REVISIONS		
REV	DESCRIPTION	DATE
1	GRAPHICS LAYOUT PROPOSAL	28/06/12

BOTTOM VIEW

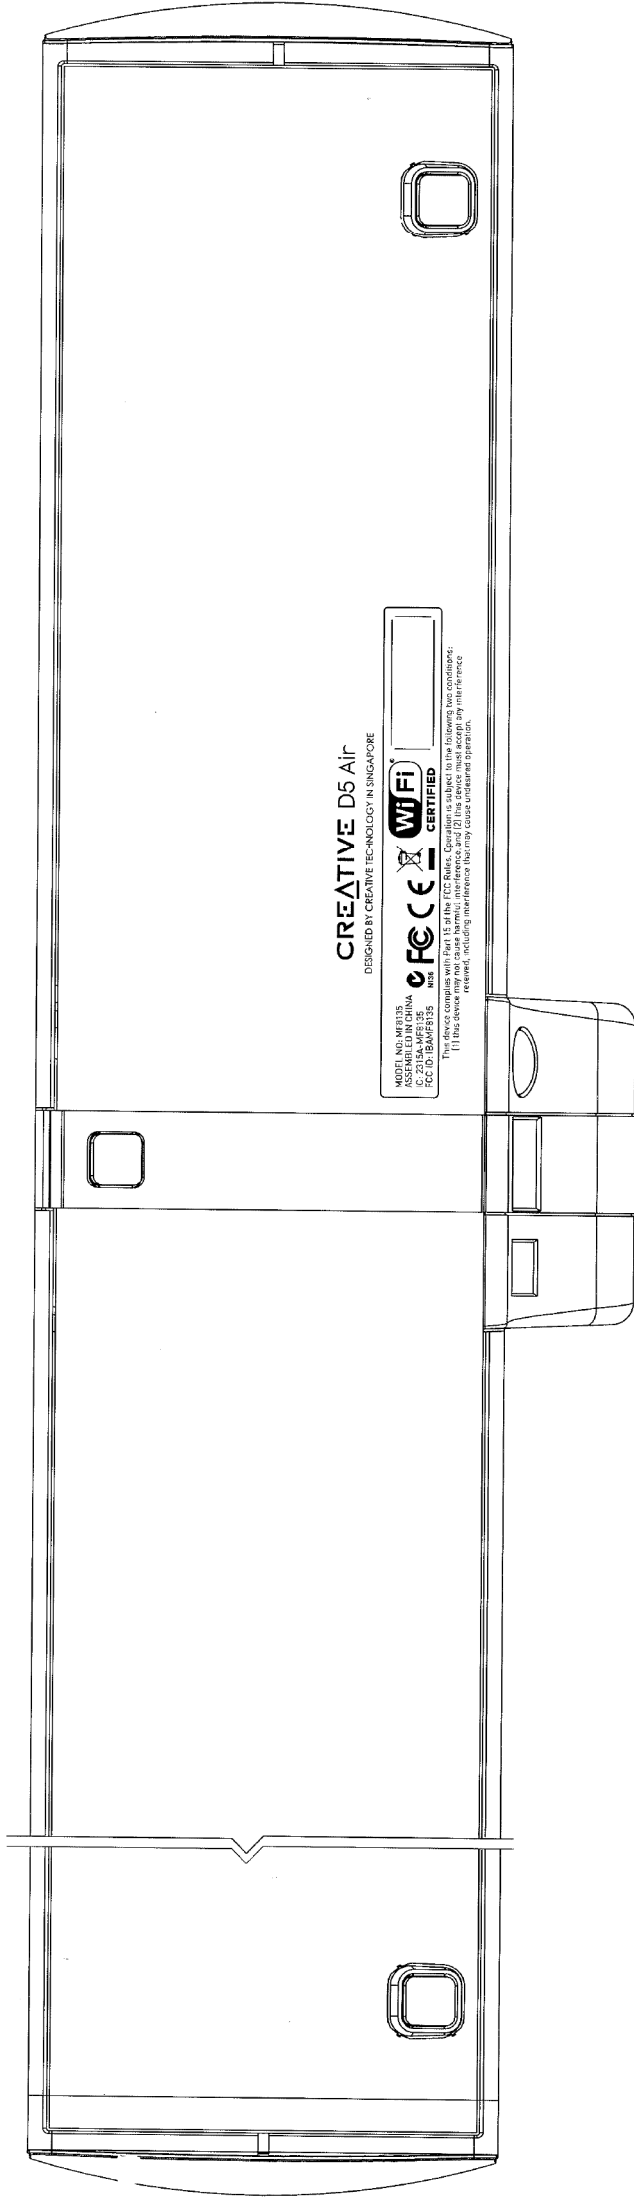
Comments: For the Wi-Fi logo, must keep the required clear space as specified in Wi-Fi marking guideline.
